The Retreat at Sacramento (P18-063)
Initial Study/Mitigated Negative Declaration
Appendix B
Revisions to Initial Study
Comments and Responses
February 20, 2019

The Retreat at Sacramento (P18-063) Initial Study/Mitigated Negative Declaration

This Responses to Comments document contains public and/or agency comments received during the public review period of the Retreat at Redding Project (proposed project) Initial Study/Mitigated Negative Declaration (IS/MND).

Figure 1
Aerial Vicinity Map

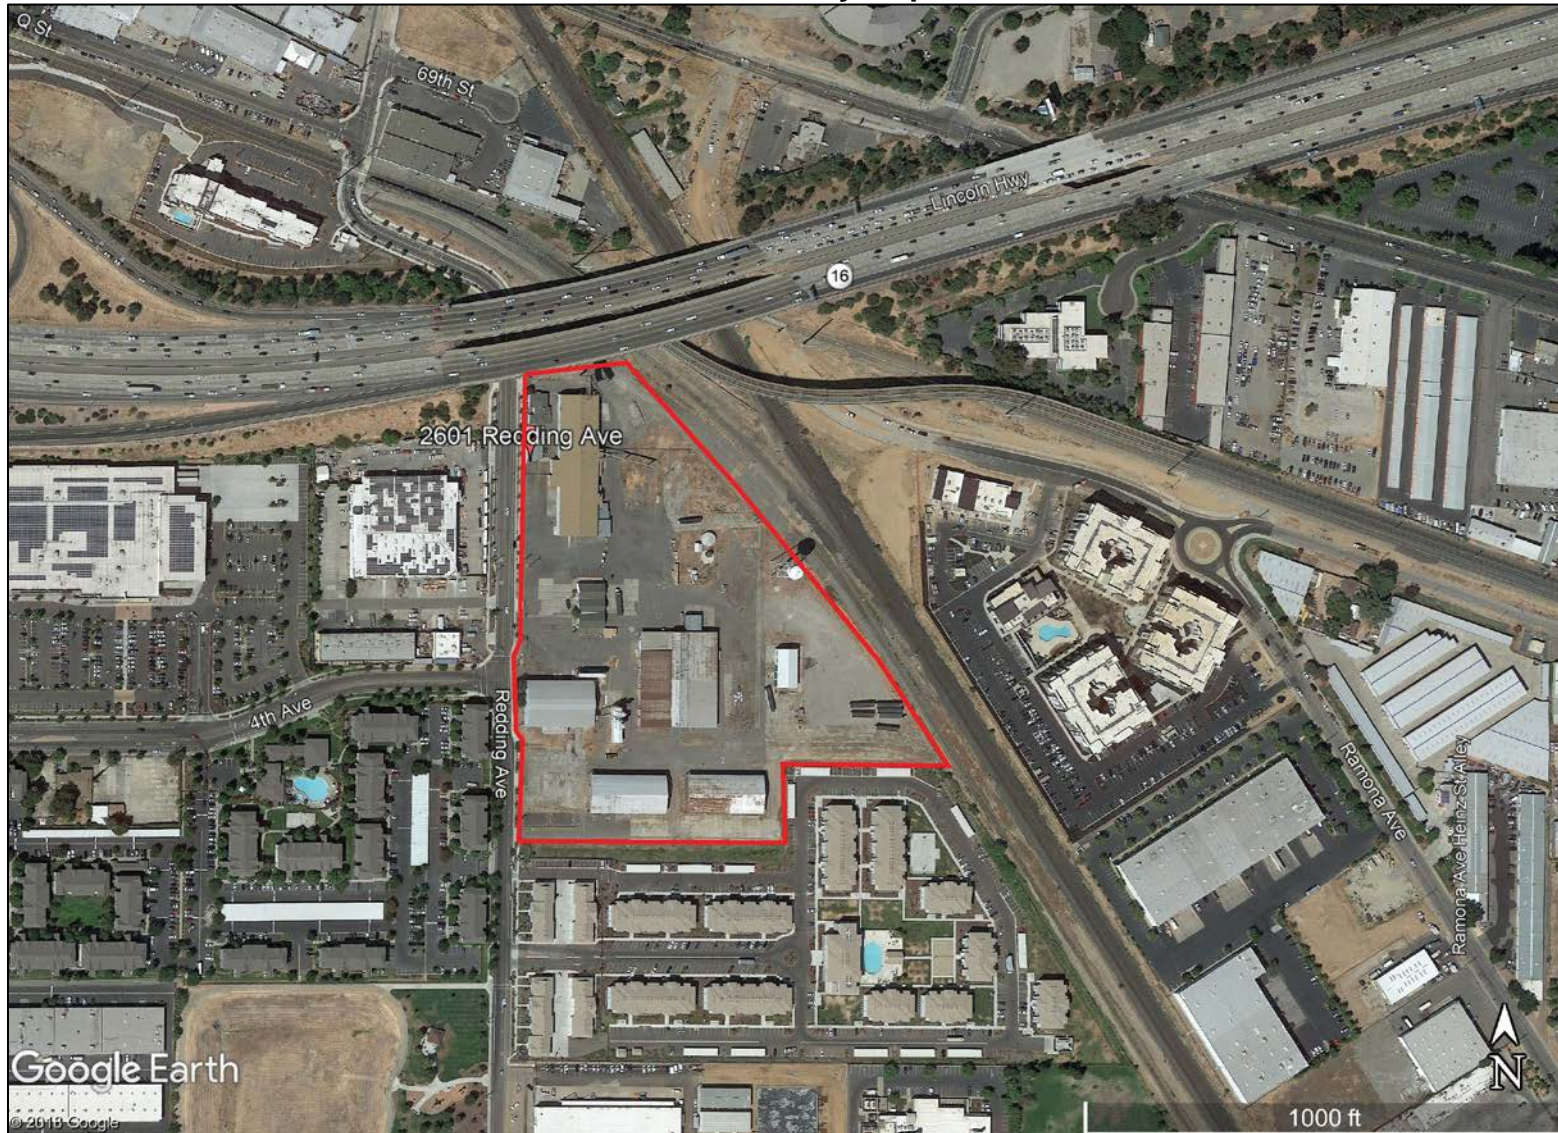
Furthermore, the project area is located within a brightly lit urban area. Substantial sources of light in the project area include the Sacramento State University Hornets Stadium (less than 0.5-mile north of the site), a 140,000 square foot Target store (less than 1,000 feet west of the site), and US 50, which is elevated above the project site’s north boundary. The chapter cited by the commenter addresses lighthouses and lightships, floodlights and ceilometers, city lights and horizon glows, fires and flares, and broadcast and communication towers. The scale of the effect of city lights and horizon glows (most relevant to the project), especially in urban Sacramento, is much broader than that of the group of residential buildings that would be developed with the project. Thus, lighting associated with the proposed project would be relatively minor relative to existing sources of light in the project area.
